SERVICE BULLETIN

PURPOSE: INFORMATION	ISSUE NO.: MSB-11E42-002	DATE: 2011-11-20	
SUBJECT : SUNROOF ASSEMBLY		<model> (EUR/RUSSIA)</model>	<m y=""></m>
GROUP : BODY		OUTLANDER (CW0W)	12

To improve the productivity, the following changes are made:

SUNROOF ASSEMBLY

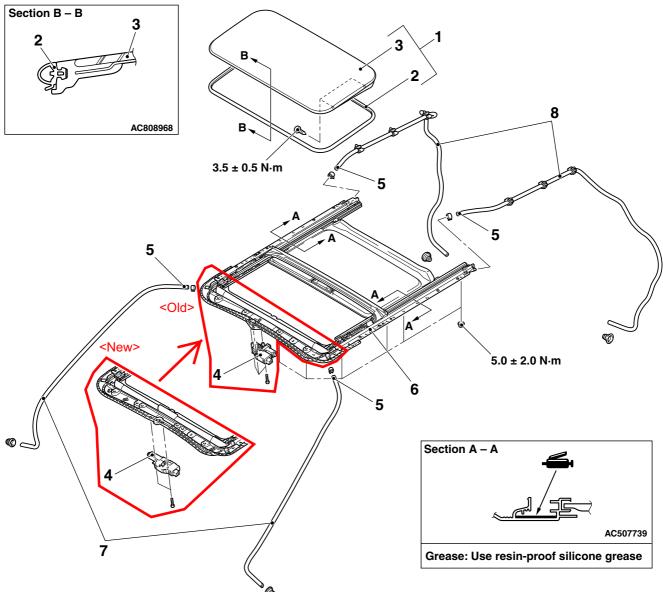
- (1) The shape of the sunroof assembly and the number of its mounting bolts (three bolts to two bolts) are changed
- (2) The front part of the sunroof housing (sunroof motor assembly mounting part) is changed
- (3) Fully closed position learning procedure is changed

REMOVAL AND INSTALLATION

Post-installation operation

- Sunroof leakage check (Refer to .)
- Sunroof alignment (Refer to .)
- Learning procedures for sunroof fully closed position (Refer to .)<Except vehicles for South Africa, Australia and New Zealand>
